# **Durham Historic Association**

## **Historic Resources Supplemental Testimony Impact of the Proposed Seacoast Reliability Project SEC Docket No. 15-04 Durham, New Hampshire July 20, 2018**

### **Eversource SRP Stone Walls List – Corrections by Durham Historic Assn January 2018**

**Class VI Road within the 'UNH Historic District' as determined by Eversource's expert**

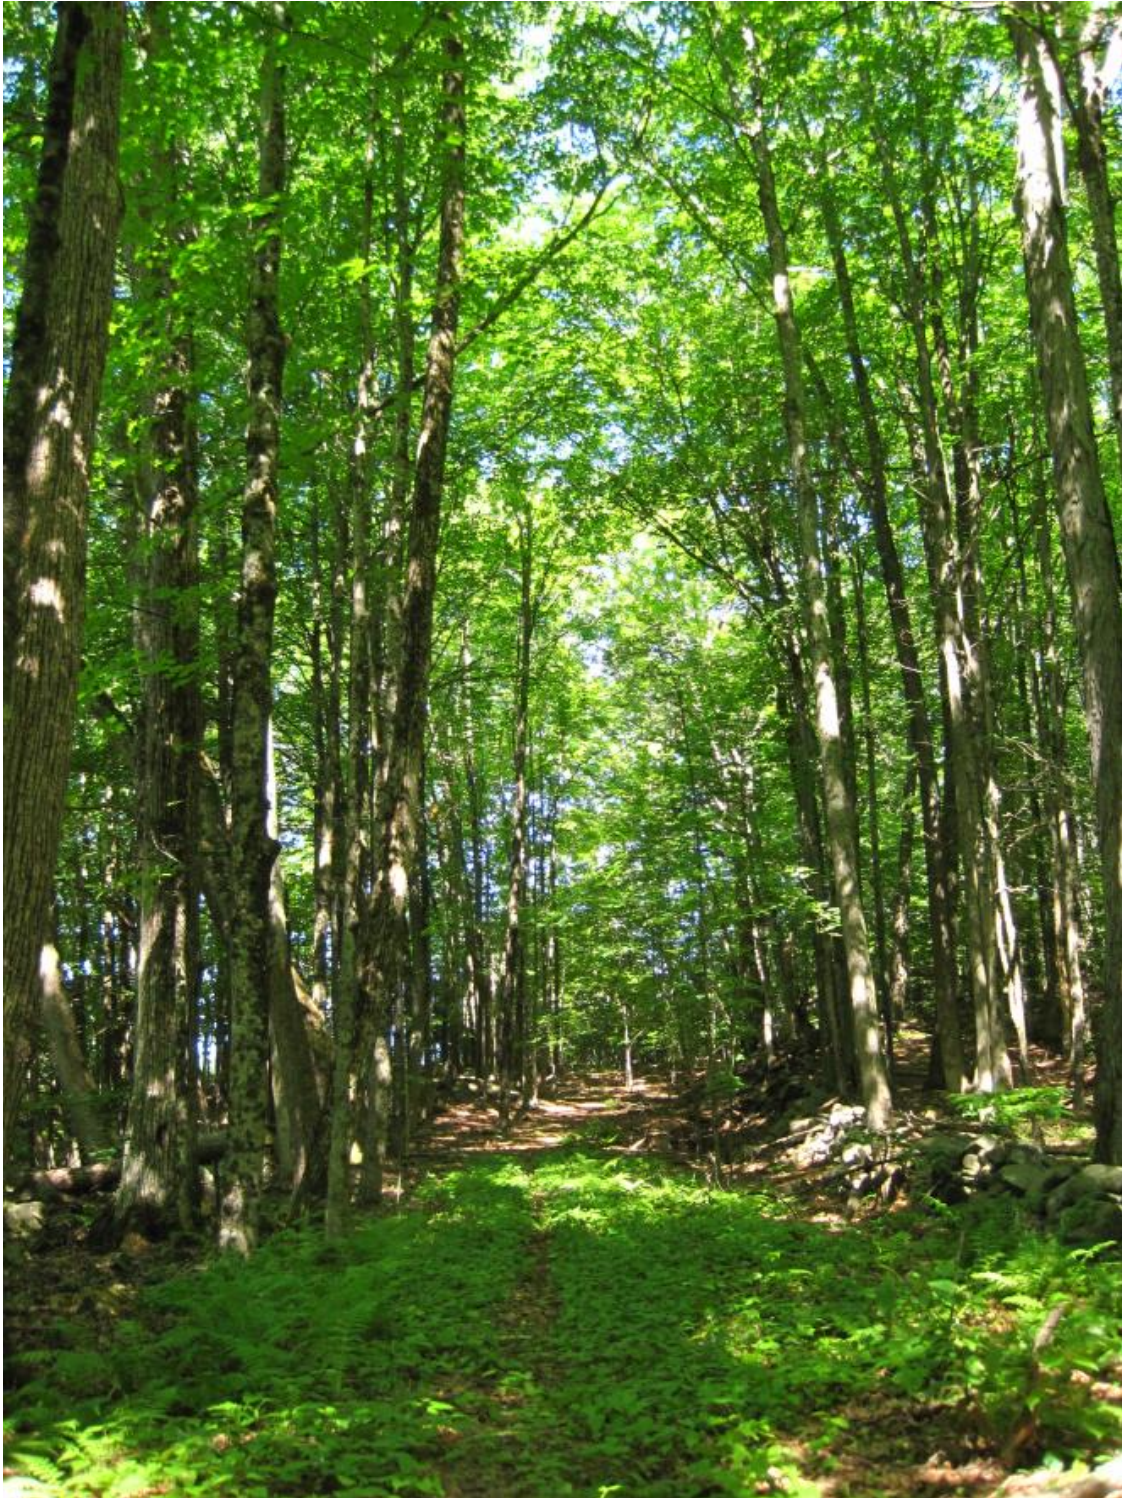
These historic roads, dating from the 1600s cannot support the weight of the construction equipment used to erect pylons. These two historic roads will be destroyed by the addition of the crushed rock or fill necessary to support the heavy equipment. Alternate access routes can be used by Eversource. The Mill Road South Branch Class VI road was visited during the June 2018 SEC bus tour.

#### **Mill Road South Branch view to the north**
